RELEASED FOR CONSTRUCTION
As Noted on Plan Review
Development Services Department
Lee's Summit, Missouri
04/26/2023

PROJECT:
Commerce Bank

New Atm Facility

160 NW Oldham Parkway Lees Summit Missouri

OVERALL SITE PLAN

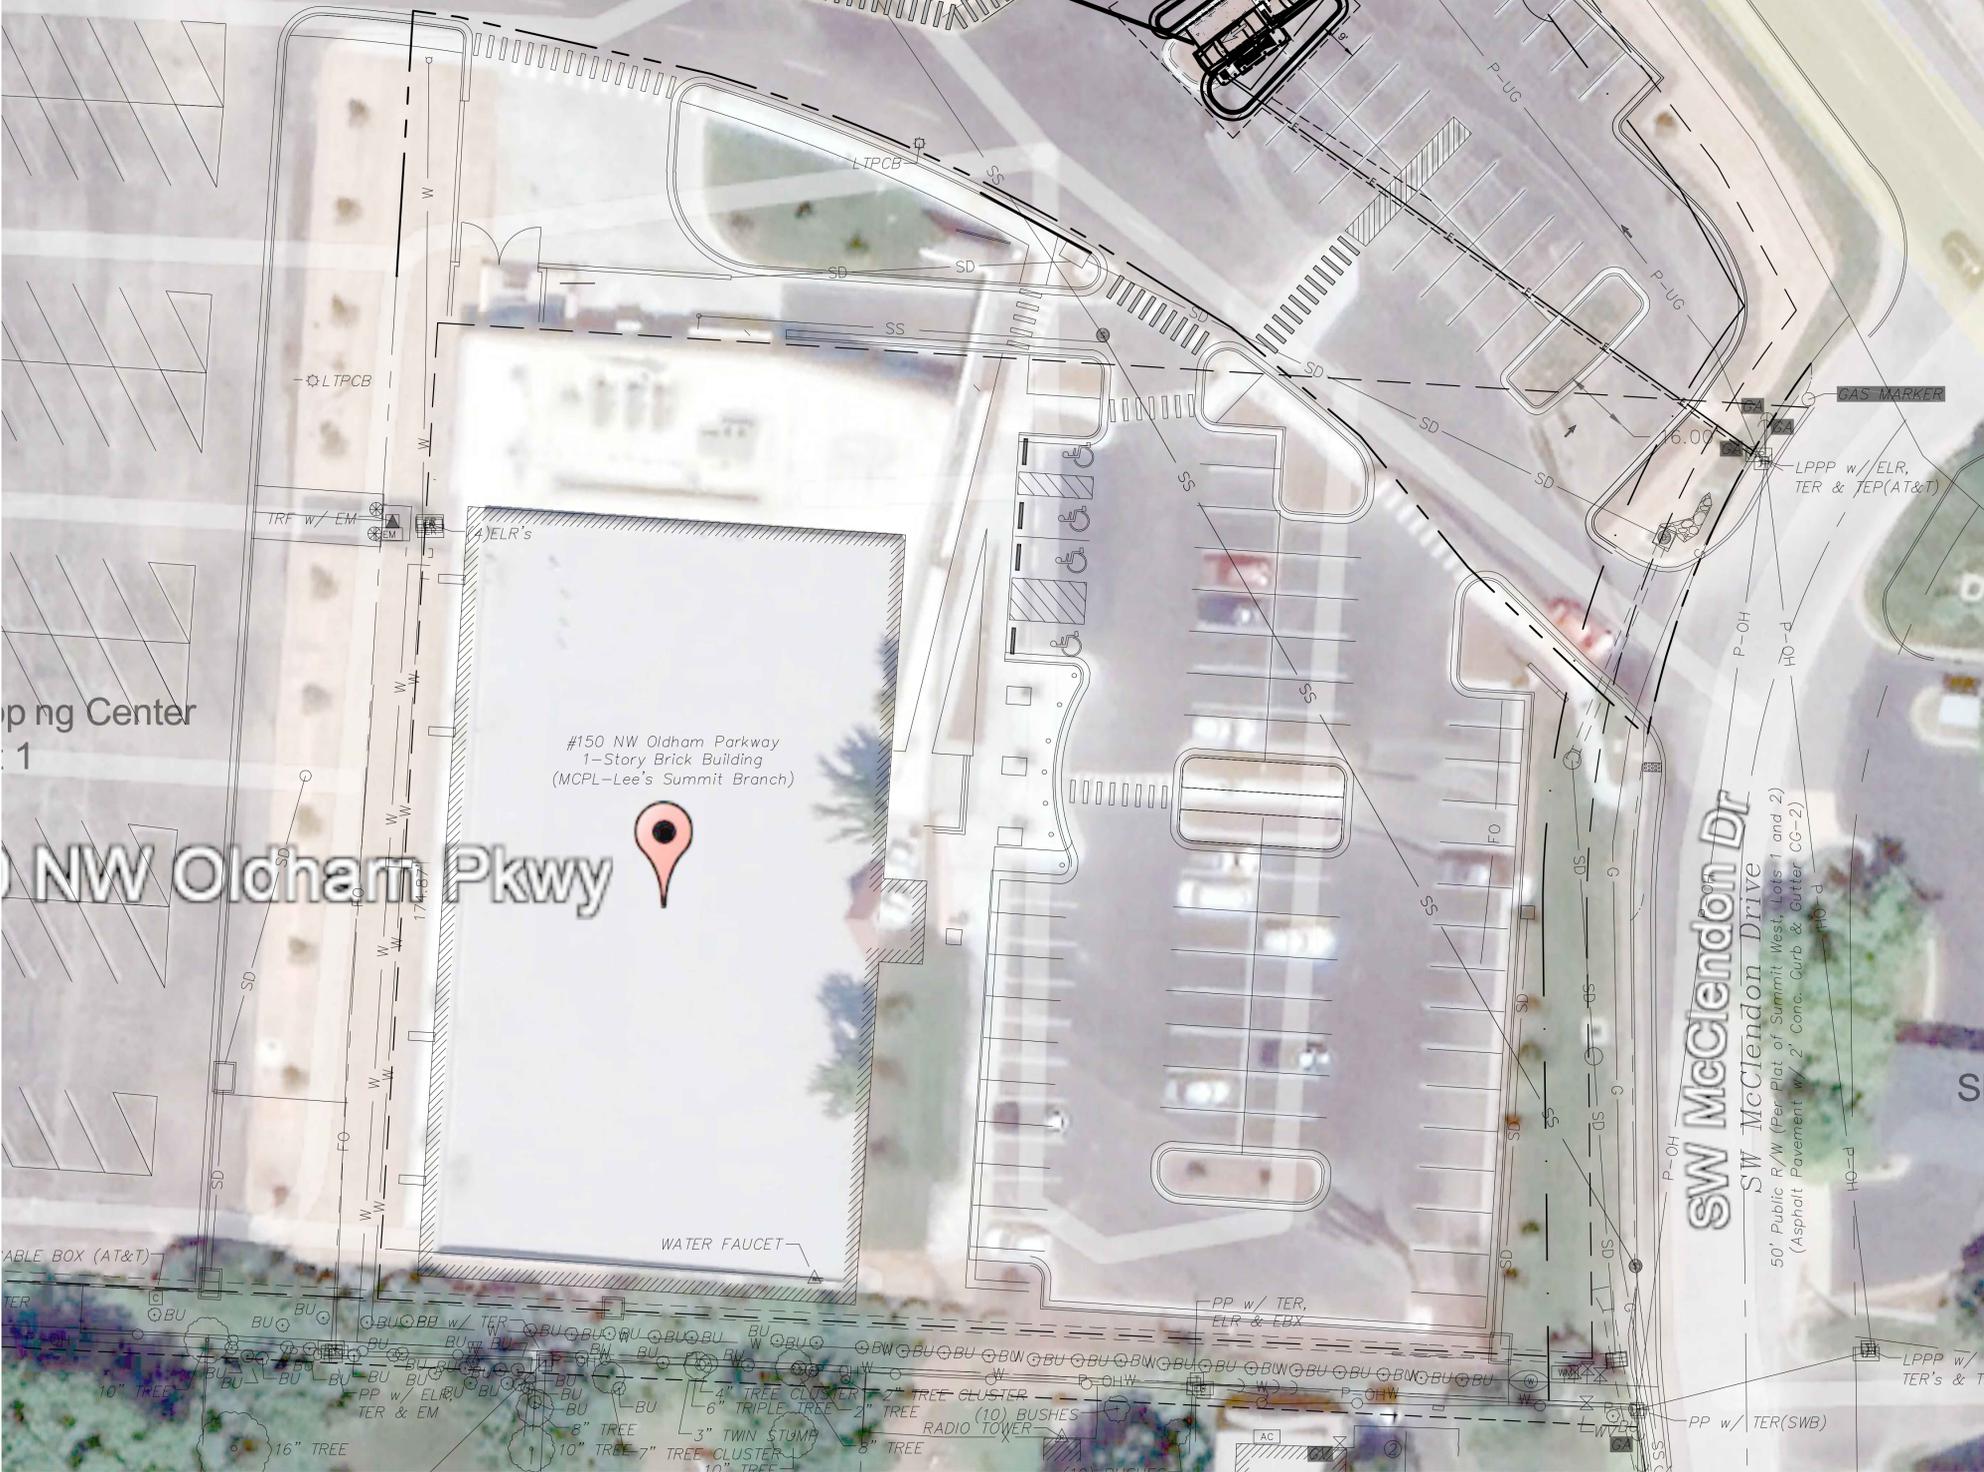
3. 2018 IBC 502.1 Address identification. New and existing buildings shall be provided with approved address identification. The address identification shall be legible and placed in a position that is visible from the street or road fronting the property. Address identification characters shall contrast with their background. Address numbers shall be Arabic numbers or alphabetical letters. Numbers shall not be spelled out. Each character shall be a minimum of 4 inches high with a minimum stroke width of 1/2 inch. Where required by the fire code official, address identification shall be provided in additional approved locations to facilitate emergency response. Where access is by means of a private road and the building address cannot be viewed from the public way, a monument, pole or other approved sign or means shall be used to identify the structure. Address identification shall be maintained. Action required: This site has been assigned the address of 160 NW Oldham Pkwy.
